New Britain Township

CONDITIONAL USE HEARING APPLICATION

Rvw #2

Reference: Celek Chalfont, LLC – Conditional Use Review 2
241 W. Butler Avenue, TMP #26-013-032

TREE BARRIER EXHIBIT

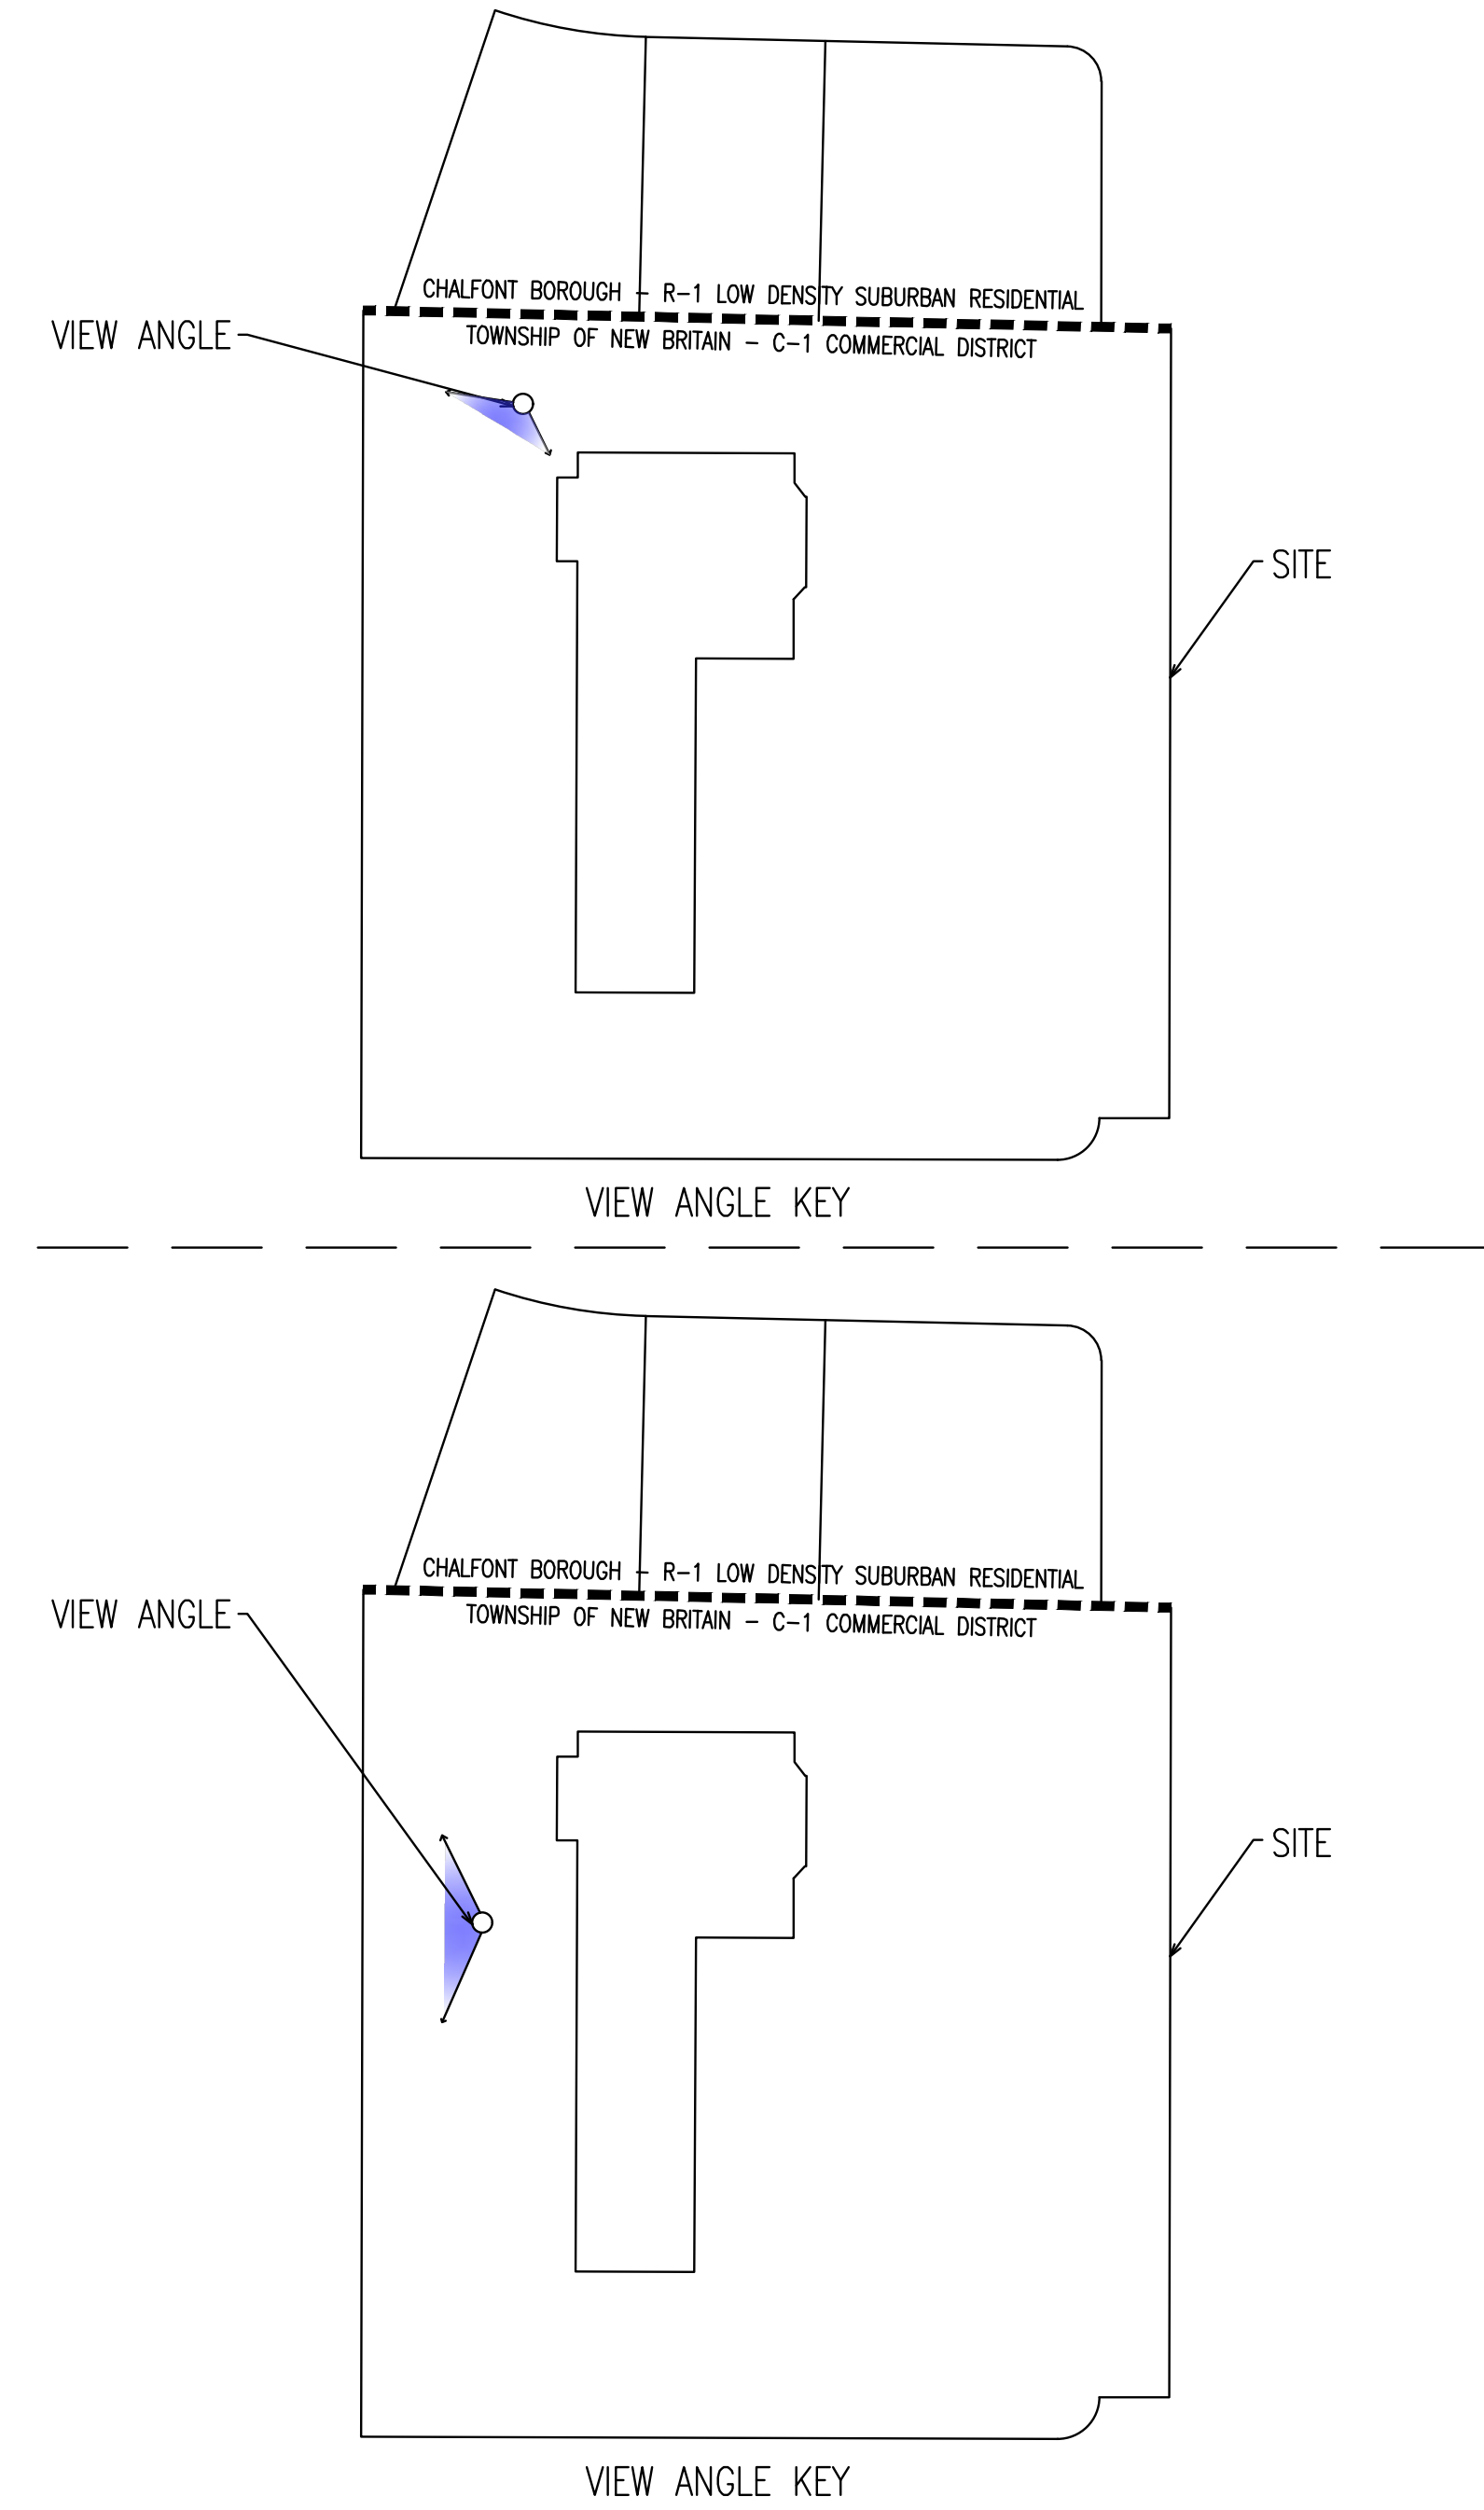
4. *Comment: §27-2800 – We recommend the condition of the existing property line buffer be assessed, maintained and supplemental plantings provided if there are gaps along the property lines shared with residential properties.*

Howell Response: The condition of the existing property line buffer between commercial and residential districts has been assessed and deemed that the current vegetation effectively serves the purpose of a visibility shield between the underlying districts. In response, Howell has prepared sheets C03.0 and C04.0 showing the view towards the residential properties.
